# Tying YANG QoS Modules to Interfaces, Not to Bridge Ports

Norman Finn  
Huawei Technologies Co. Ltd  
cw-finn-interfaces-not-ports-0920-v02  
21` September, 2020

# Where are QoS controls in IEEE Std 802.1Q?

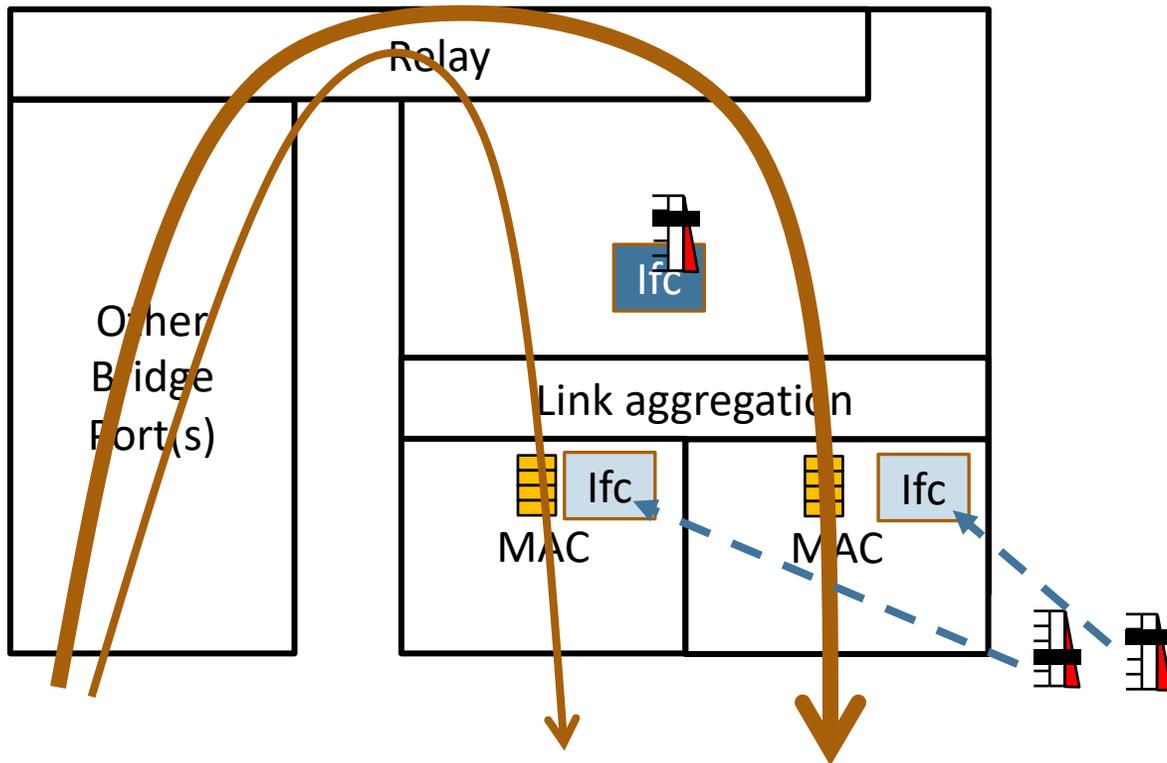
- When Link Aggregation (IEEE Std 802.3ad, later IEEE Std 802.1AX) was introduced, it still didn't matter whether one put the queues in the center or in a physical port, because strict priority works just the same if the bridge port parameters are applied to individual physical ports' queues.
- The addition of Enhanced Transmission Selection (ETS, aka Weighted Fair Queuing) did not change this indifference; the bridge port parameters can be replicated to the physical ports, and everything works as expected.
